SUBJECT: Responds to SER Open Items 15 & FSAR Question 0040.084, re qualification of diesel generator auxiliaries. Util disagrees w/NRC proposal to upgrade skid-mounted diesel generator auxiliaries to ASME Section III Class 3 requirements.

May 25, 1982
G02-82-466
SS-L-02-KAH-82-001

Subject: NUCLEAR PROJECT NO. 2
SER OPEN ITEMS - DIESEL GENERATOR
AUXILIARY QUALIFICATIONS

FIGURE
9.5-4

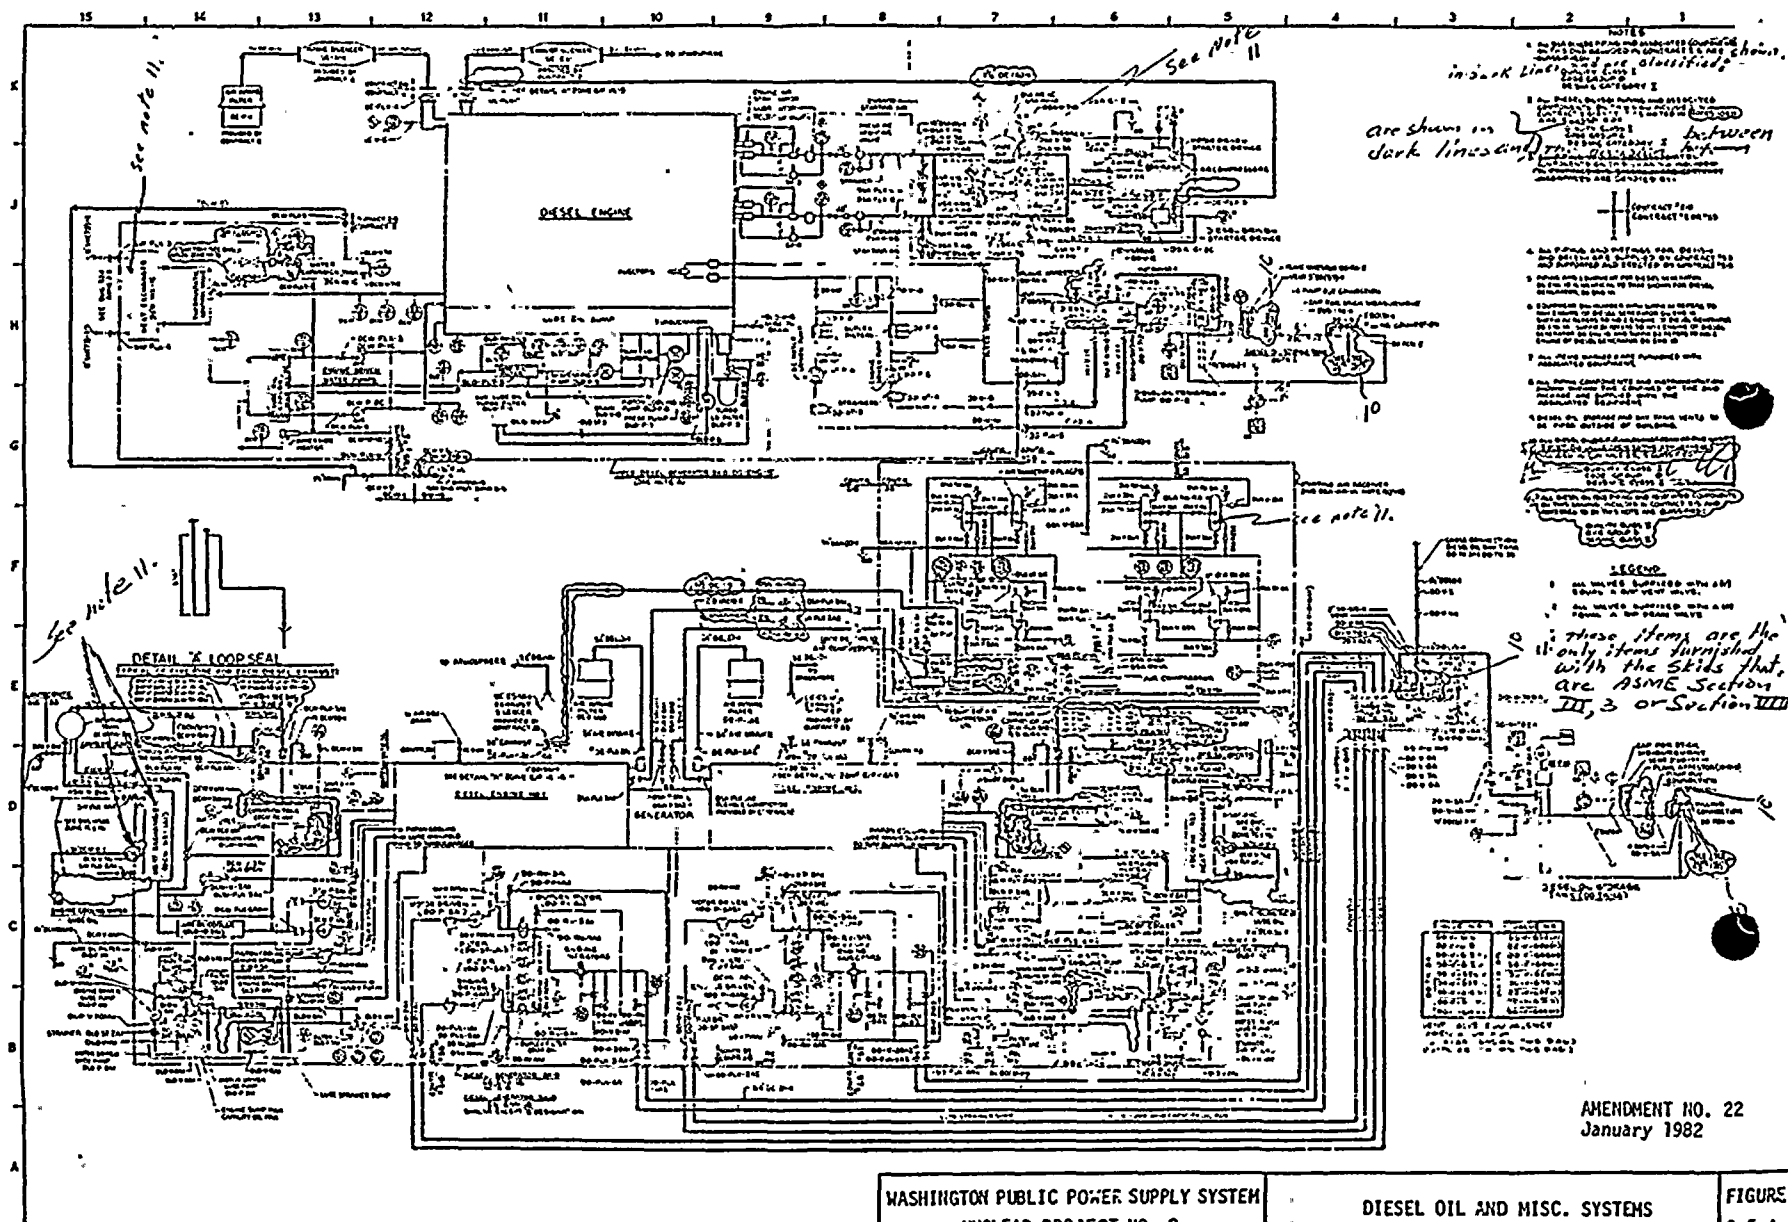
This letter is provided in response to SER Open Item 15 and FSAR Question Q040.084, regarding qualification of diesel generator auxiliaries. Accordingly, please find attached marked-up revisions to FSAR Table 3.2-1 and Figure 9.5-4, which will be incorporated into a future FSAR amendment. Also attached is a detailed response to Q040.084.

The FSAR text, Table 3.2-1 and Figure 9.54 show that the components and piping systems for the diesel generator auxiliaries (fuel oil system, cooling water, lubrication, air starting, and intake and combustion systems) that are mounted on the auxiliary skids are designed to Seismic Category I, and ASME Section III, Class 3 quality, or designed to ANSI B31.1. The engine-mounted components and piping are normally designed and manufactured to DEMA standards, and are Seismic Category I. This is not in accordance with Regulatory Guide 1.26 which requires the entire diesel generator auxiliary systems to be designed to ASME Section III, Class 3 or Quality Group C.

- a. Upgrade the generator auxiliary systems components and piping up to the engine interface to ASME Section III, Class 3 (Quality Group C) requirements.
- b. Provide the industry standards that are used in the design, manufacture, and inspection of the engine-mounted piping and components. Also show on the appropriate P&ID's where the Quality Group Classification changes from Quality Group C.

The diesel generator auxiliaries are separated into three different segments for design and manufacture, as shown on Figure 9.5-4:

- The auxiliaries that were supplied as a part of the diesel engine skid and diesel starting air skid.
- The fuel oil storage tanks and day tanks (provided by a tank fabricator).
- The piping that connects the DSA skid with the engine skid, fuel oil storage tanks and day tanks to the engine skid, the cooling water reservoir tank to the cooling water heat exchanger and the diesel engine air intake and exhaust (designed by the Architect/Engineer and supplied and installed by the mechanical contractor).

The fuel oil piping up to the diesel engine skid, and the cooling water system's piping and components up to the diesel engine heat exchanger, are designed, fabricated, inspected, installed, examined, and tested in accordance with ASME Section III, Class 3 requirements.

The piping connecting the diesel oil storage tank, day tank, and engine skid, is ASME Section III, Class 3. The piping connecting the DSA skid to the engine skid and the piping connecting the cooling water reservoir tank and the cooling water heat exchanger are designed, fabricated, inspected, installed, examined, and tested in accordance with ANSI B31.1, plus are Quality Class I, Seismic Category I, liquid penetrant examined (for piping over 4" IPS), and hydrostatically tested to 1.5 times design pressure. Therefore, the technical differences between ANSI B31.1 and ASME Section III, Class 3 are completely eliminated for this portion of the auxiliaries.

The starting air, air intake, and exhaust systems piping and components (except the air receivers which are ASME Section VIII, Division 1), up to the diesel engine interface, are designed, fabricated, inspected, installed, examined, and tested in accordance with ANSI B31.1 requirements. These

systems are Quality Class I and Seismic Category I. Piping over 4" in diameter are liquid penetrant examined as required by ASME Section III. The time at operating pressure during preoperational testing will be as likely to expose a leak as would occur during operation at the higher, but shorter duration test time of 10 minutes required by ASME Section III, Class 3. Therefore, the technical differences between ANSI B31.1 and ASME Section III, Class 3 are largely closed.
